PREPARED FOR THE PLAN COMMISSION

Project Address: 223 South Pinckney Street (District 4- Ald. Verveer)
Application Type: Demolition Permit, Planned Development Alteration, Conditional Use, and Certified Survey Map
Legistar File ID # [55916](#), [55921](#), [56121](#), & [56288](#)
Prepared By: Kevin Firchow, AICP, Planning Division
Report includes comments from other City agencies, as noted
Reviewed By: Heather Stouder, AICP, Planning Division Director

Summary

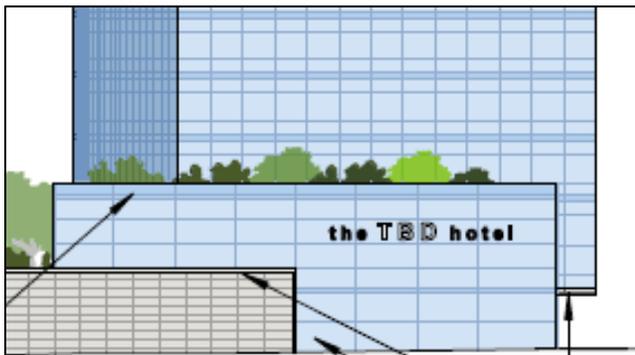
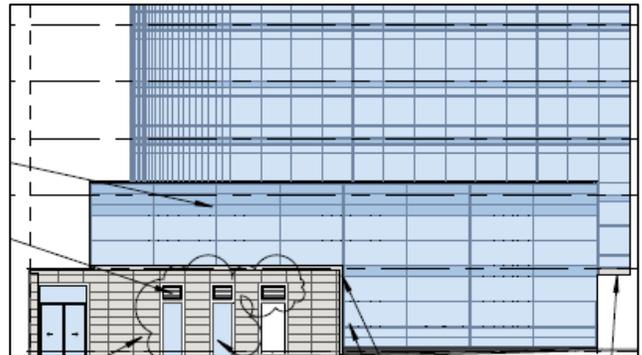
Corresponding façade changes are proposed to the East Wilson and Doty Street facades. Along Wilson Street, the previously approved underground parking entrance is now comprised of a door and spandrel-clad panels. Along Doty Street, additional windows and doors to an enclosed bike parking area are now proposed. No changes are proposed along South Pinckney Street.

Alterations to approved Planned Developments require review by either the Urban Design Commission (UDC) or the UDC Secretary. Considering the limited scope of changes above grade, the UDC Secretary has reviewed this request on behalf of the Commission. The Secretary believes that the removal of the parking ramp access and the corresponding East Wilson Street façade modifications improve the pedestrian character of this block face. Similarly, the changes on East Doty Street are believed by the Secretary to be in keeping with the previous
